PENRITH CITY COUNCIL

MAJOR ASSESSMENT REPORT

Application number:	DA17/0386
Proposed development:	Demolition of Existing Structures & Construction of Five (5) Storey Residential Flat Building containing 19 Apartments & Two (2) Levels of Basement Car Parking
Property address:	15 Dent Street, JAMISONTOWN NSW 2750 17 Dent Street, JAMISONTOWN NSW 2750
Property description:	Lot SP 79056 Lot 32 DP 1283
Date received:	11 May 2017
Assessing officer	Lauren Van Etten
Zoning:	Zone R4 High Density Residential - LEP 2010
Class of building:	Class 2 , Class 7a
Recommendations:	Approve

SCALE 1:200
GROUND FLOOR PLAN SHOWING STORMWATER MANAGEMENT

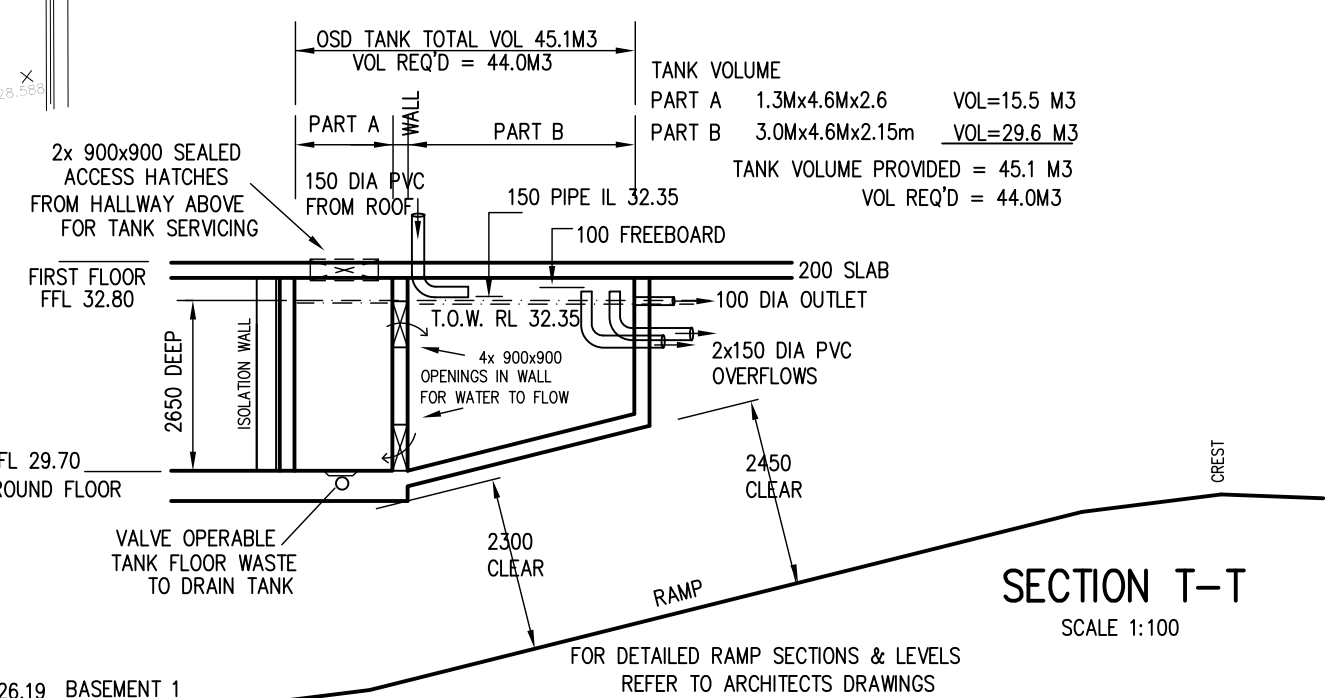
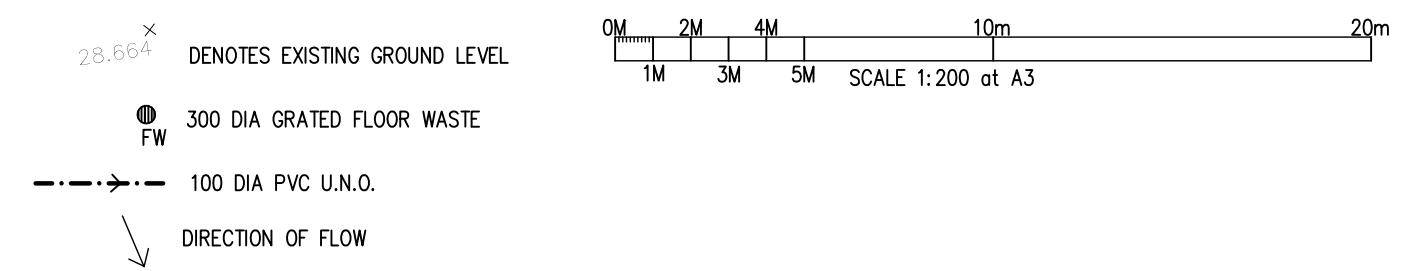
The MUSIC model screen shot indicates that 10 * 460mm Psorb storm filters and 2 enviropods will be used as well as a 10kL rainwater tank. However, no details are shown on the drainage plans.

- The concept plans shall be amended to reflect the inclusion of the commitments made in relation to the supporting MUSIC link report and Modelling which included the installation of 10 * 460mm PSORB Storm filter Cartridges.
 - A detailed operation and maintenance manual shall be prepared and submitted to Council for approval.
